Project	<b>IEEE 802.16 Broadband Wireless Access Working Group</b> < <a href="http://ieee802.org/16">http://ieee802.org/16</a> >	
Title	<b>Fixes for Loss of Handover Messages</b>	
Date Submitted	<b>2008-01-16</b>	
Source(s)	Chi-Chen Lee, I-Kang Fu, Kelvin Chou, Paul Cheng MediaTek Inc. No. 1, Dusing Rd. 1 Science-Based Industrial Park, Hsinchu, Taiwan 300	<a href="mailto:chichen.lee@mediatek.com">chichen.lee@mediatek.com</a> <a href="mailto:ik.fu@mediatek.com">ik.fu@mediatek.com</a> <a href="mailto:kelvin.chou@mediatek.com">kelvin.chou@mediatek.com</a> <a href="mailto:paul.cheng@mediatek.com">paul.cheng@mediatek.com</a>
Re:	IEEE 802.16 Working Group Letter Ballot Recirc #26a	
Abstract	The behavior of MS/BS in response to the loss of MOB_HO-IND messages during a HO has not been defined in P802.16Rev/D2, which leads to asynchronization between MS and its Serving BS and potential insecurity. A remedy is proposed to address this issue.

## Fixes for Loss of Handover Cancellation Messages

## Suggested Changes in Rev2/D2

Figure 1 – Loss of MOB\_HO-IND messages during HO handshake

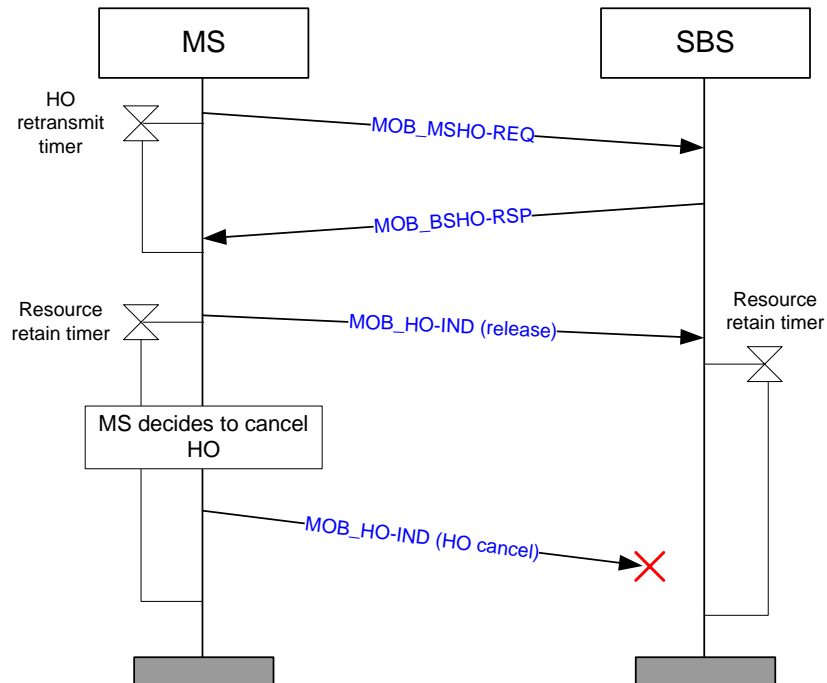
As shown in Figure 1, during the HO handshake, both MS and its SBS will not be notified the loss of MOB\_HO-IND message since there is no Ack for the MOB\_HO-IND message. If the MOB\_HO-IND message with HO\_IND\_type being *0b00* (SBS release) is lost, SBS may still learn the HO of MS through the notification from target BSs. However, the loss of MOB\_HO-IND message with HO\_IND\_type being *0b01* (HO cancel) makes MS and SBS have different perception of the MS status, i.e. MS considers the HO has been canceled while SBS considers the HO has been performed. Furthermore, if the MOB\_HO-IND with HO cancel, which contains the HMAC/CMAC Tuple, is lost and SBS still accepts subsequent BW requests, a malicious MS may attack or steal the BW from the SBS by sending BW requests to it.

Figure 2 – Loss of HO cancel before MOB\_BSHO-RSP is sent by SBS

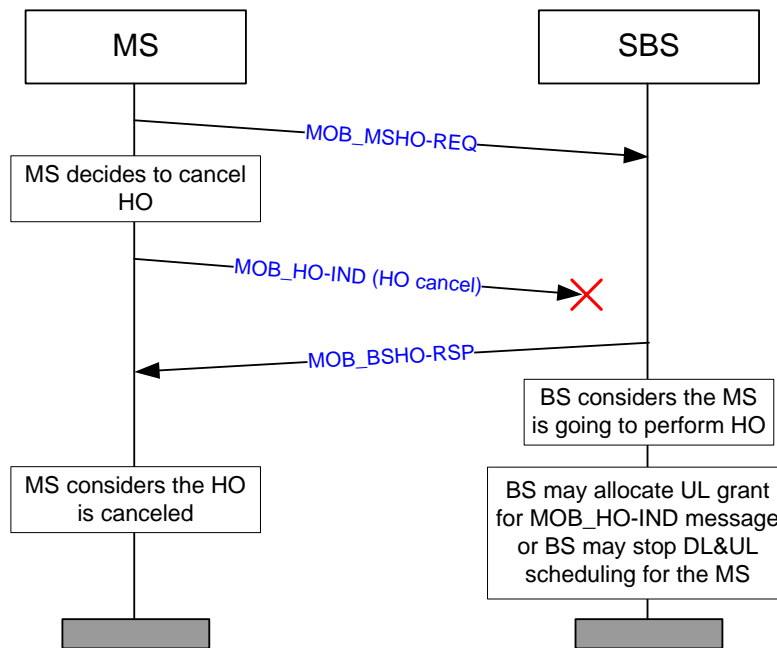
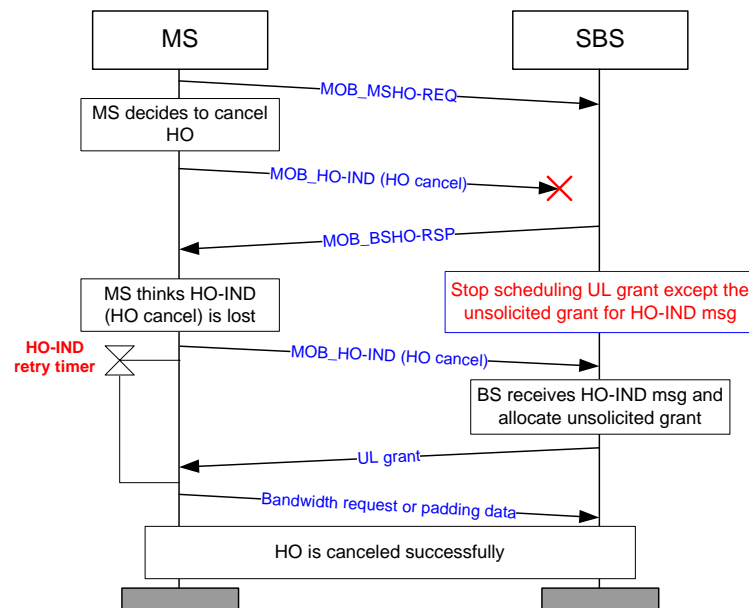
**Scenario 1 (MS initiated HO):** MS decides to cancel HO right after it sent the MOB\_MSHO-REQ message, and the following MOB\_HO-IND with HO cancel is lost. MS will consider that the HO is canceled, while SBS will consider that MS continues HO and may stop DL&UL scheduling for the MS, as illustrated in Figure 2.

If MS sends MOB\_HO-IND message with HO cancel or HO reject right after sending MOB\_MSHO-REQ, but receives MOB\_BSHO-RSP from SBS, it shall consider that its HO cancel or HO reject message has been lost. In this case, it shall retransmit another MOB\_HO-IND message with HO cancel or HO reject and start HO-IND retry timer immediately.

Figure 8 - Suggested remedy for scenario 1

Figure 3 – Loss of HO cancel or HO reject after MOB\_BSHO-RSP is received by MS

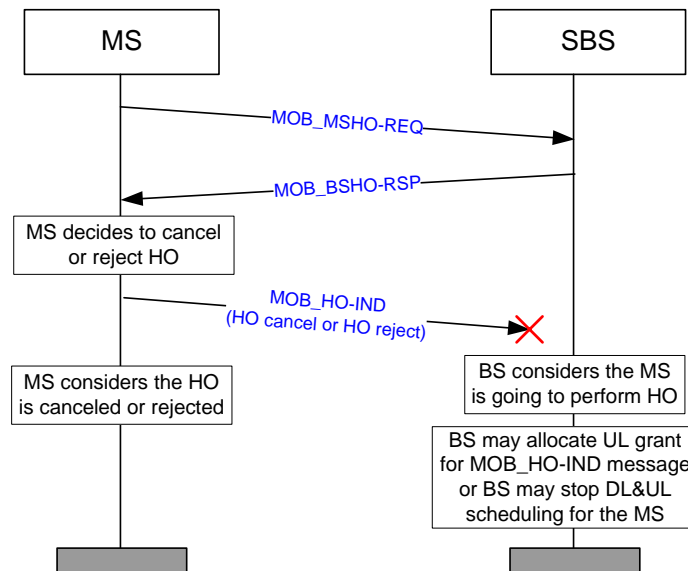
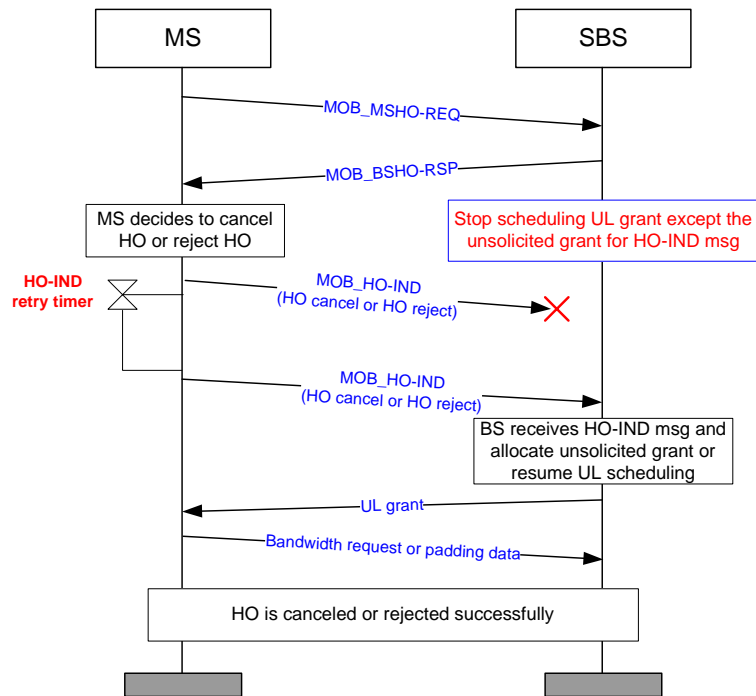
**Scenario 2 (MS initiated HO):** MS decides to cancel or reject HO right after it received the MOB\_BSHO-RSP message, and the following MOB\_HO-IND with HO cancel or HO reject is lost. MS will consider that the HO is canceled or rejected, while SBS will consider that MS continues HO and may stop DL&UL scheduling for the MS, as illustrated in Figure 3.

Figure 9 – Suggested remedy for scenario 2

Figure 4 – Loss of HO cancel after MOB\_HO-IND with SBS release is sent by MS

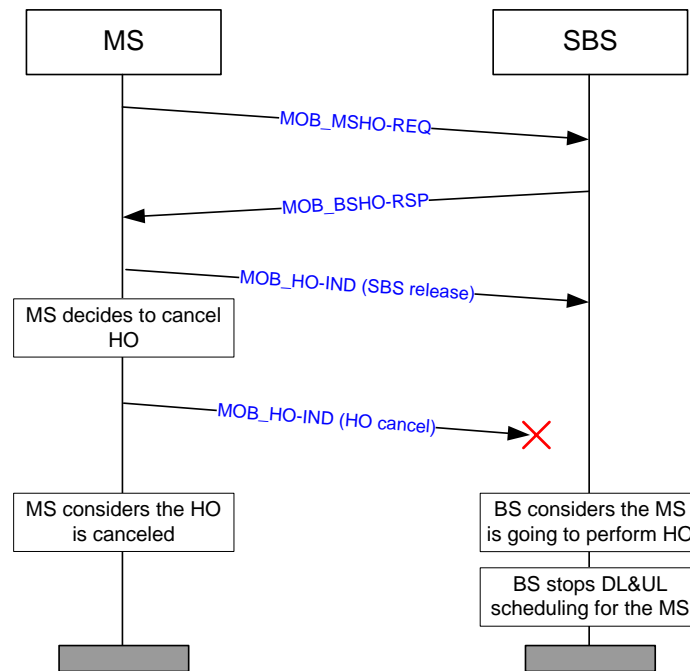
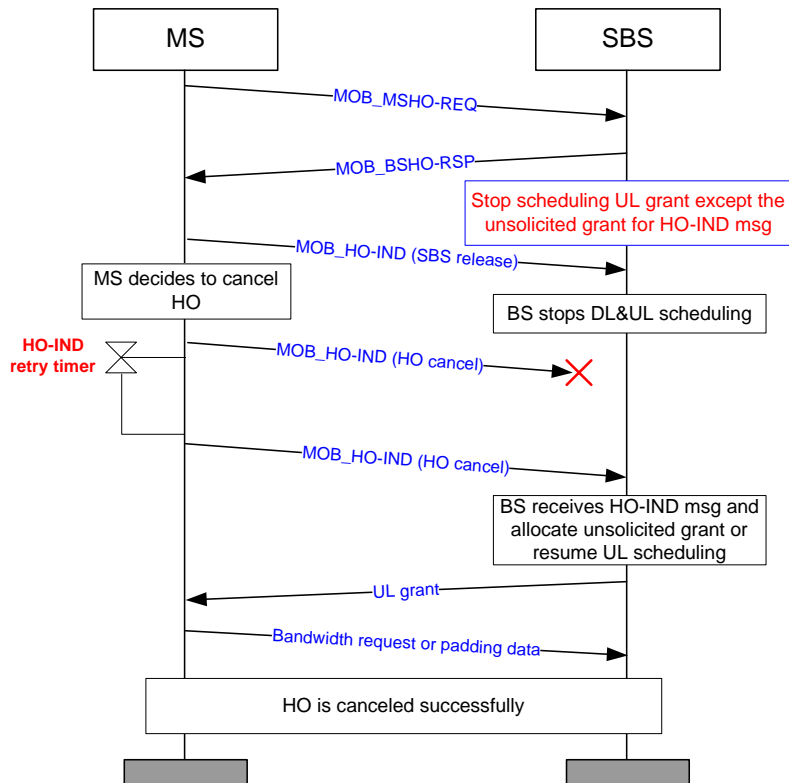
**Scenario 3 (MS initiated HO):** MS decides to cancel HO right after it sent the MOB\_HO-IND message with SBS release, and the following MOB\_HO-IND with HO cancel is lost. MS will consider that the HO is canceled, while SBS will consider that MS continues HO and will stop DL&UL scheduling for the MS, as illustrated in Figure 4.

Figure 10 – Suggested remedy for scenario 3

Figure 5 – Loss of HO cancel or HO reject after MOB\_BSHO-REQ is received by MS

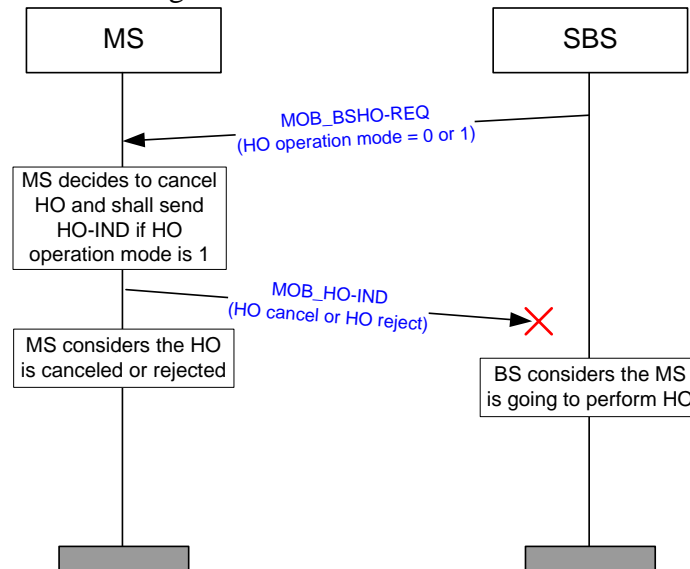
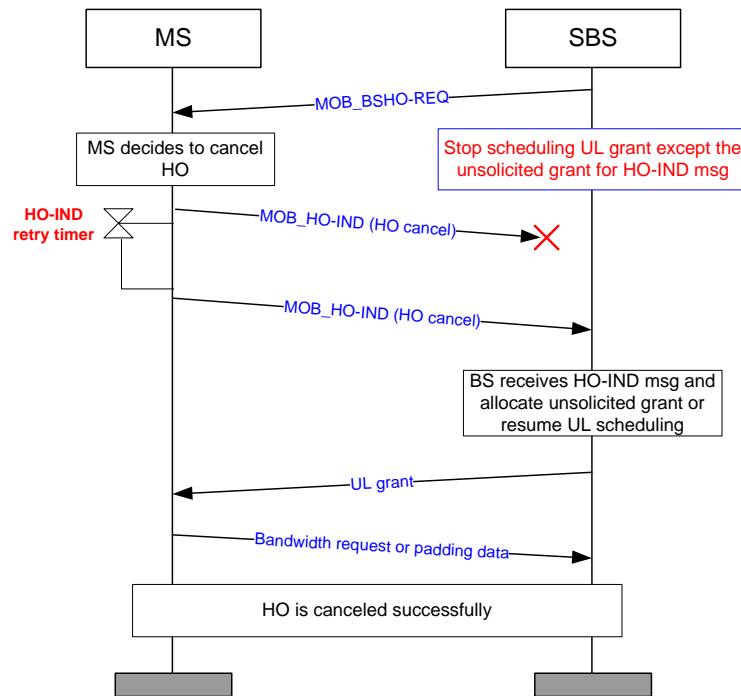
**Scenario 4 (BS initiated HO):** MS decides to cancel or reject HO right after it received the MOB\_BSHO-REQ message from SBS, and the following MOB\_HO-IND with HO cancel or HO reject is lost. MS will consider that the HO is canceled or rejected, while SBS will consider that MS continues HO and may stop DL&UL scheduling for the MS, as illustrated in Figure 5.

Figure 11 – Suggested remedy for scenario 4

Figure 6 – Loss of HO cancel after MOB\_HO-IND with SBS release is sent by MS

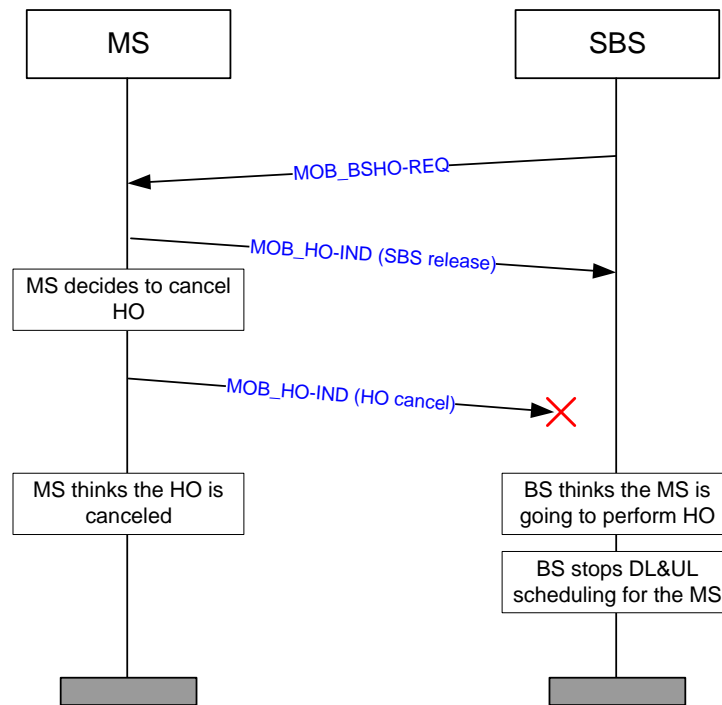
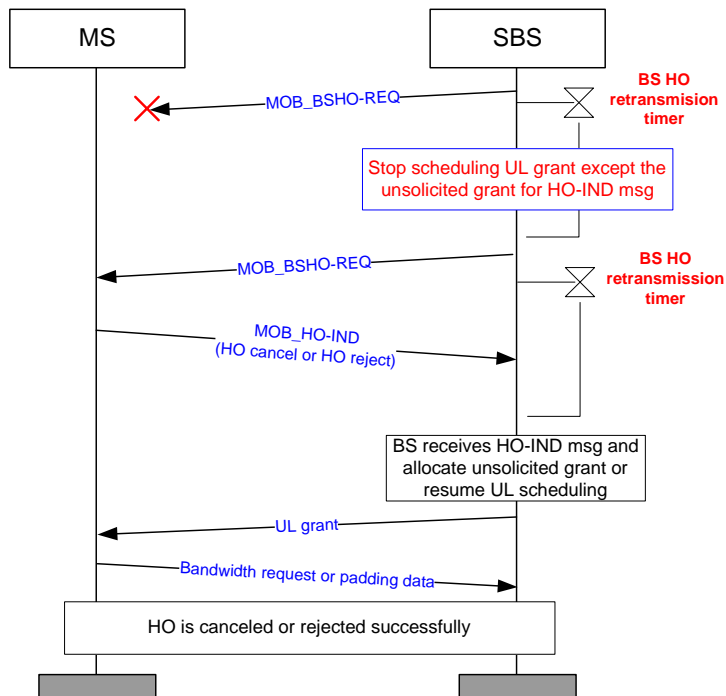
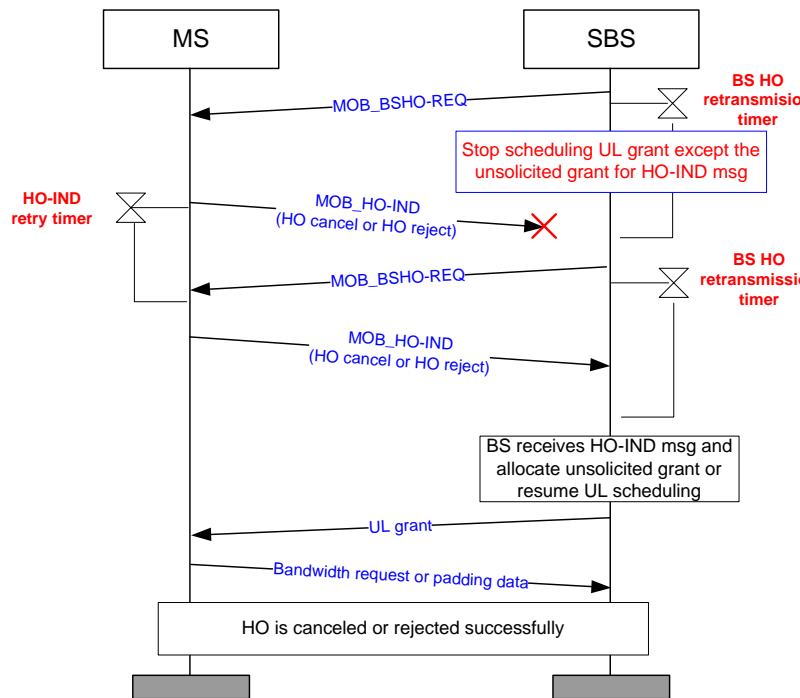
**Scenario 5 (BS initiated HO):** MS decides to cancel HO right after it sent the MOB\_HO-IND message with SBS release, and the following MOB\_HO-IND with HO cancel is lost. MS will consider that the HO is canceled, while SBS will consider that MS continues HO and will stop DL&UL scheduling for the MS, as illustrated in Figure 6.

Figure 12 – Suggested remedy for scenario 5 and 6

Figure 13 – Suggested remedy for scenario 5 and 6

Figure 7 - Loss of MOB\_BSHO-REQ

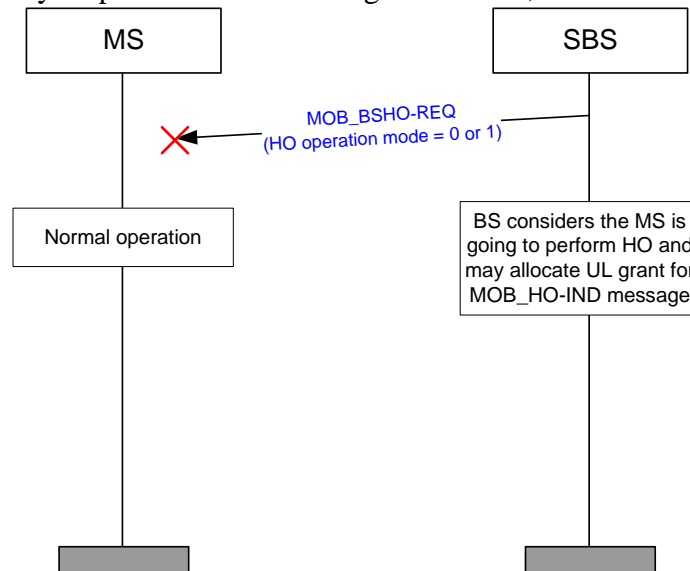
**Scenario 6 (BS initiated HO):** MOB\_BSHO-REQ message is lost. In this case, MS will remain at normal operation, while SBS will consider that MS continues HO and may allocate unsolicited UL grant for MOB\_HO-IND message or may stop DL&UL scheduling for the MS, as illustrated in Figure 7.
